TSB#: EL-0001

TECHNICAL SERVICE BULLETIN

2013 F250/350, 6.2L A/T – BI-FUEL CONVERSION SYSTEMS ONLY.

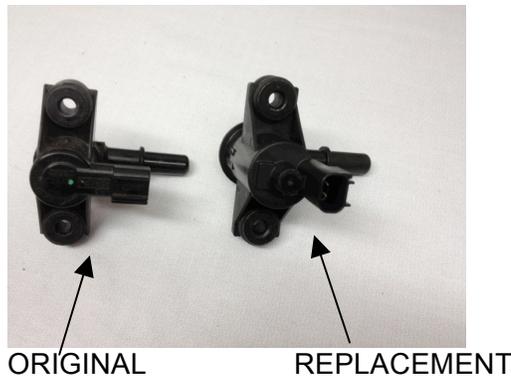
THE PCV ELECTRICAL CONNECTOR INTERFERES WITH THE CNG FUEL RAIL ON BI-FUEL CONVERSIONS.

REPLACE THE PCV VALVE AS OUTLINED IN THE SERVICE PROCEDURE.

REMOVE PCV VALVE AND REPLACE WITH SUPPLIED COMPONENT.
